**Standardization of technical and safety requirements
in inland navigation: European Code for Inland
Waterways (CEVNI) (Resolution No. 24, revision 5)**

Outcome of the twenty-fifth meeting of the Informal CEVNI Expert Group and amendments to the European Code for Inland Waterways

Draft minutes of the twenty-fifth meeting of the CEVNI Expert Group

(fig. 23 bis)

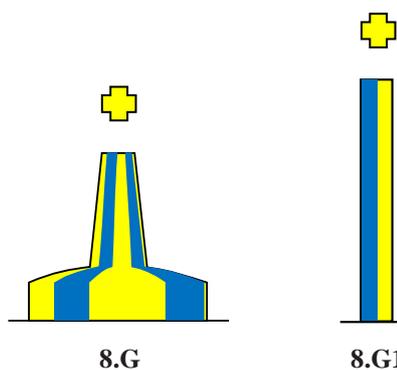
(b) *Add* a new para. 3 to section VI A, introducing the new danger mark:

3. Marking of new dangers

The term “New Danger” is used to describe newly discovered hazards not yet shown in nautical documents. New Dangers include naturally occurring obstructions such as sand banks or rocks or man-made dangers such as wrecks.

Colour: Blue and yellow vertical stripes
in equal number dimensions
(minimum 4 stripes and maximum 8)

Form: pillar or spar

Topmark (if any): vertical or perpendicular
yellow cross

Light (when fitted):

Colour: yellow/blue alternating

Rhythm: one second of blue light and one
second of yellow light with 0.5 seconds
of darkness between.

(fig.24 bis)

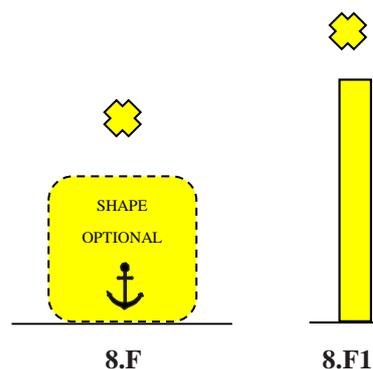
(c) *Add* a new section VI B bis:

B BIS SPECIAL MARKS

Marks not primarily intended to assist navigation but which indicate a special area or feature referred to in appropriate documents, such as military exercise zone marks, recreation zone marks.

Colour: yellow

Shape: optional, but not conflicting with navigational marks

Topmark if any: single yellow, "X" shape

Light:

Colour: yellow

Rhythm: any, other than those described in A.2, A.3 and B.
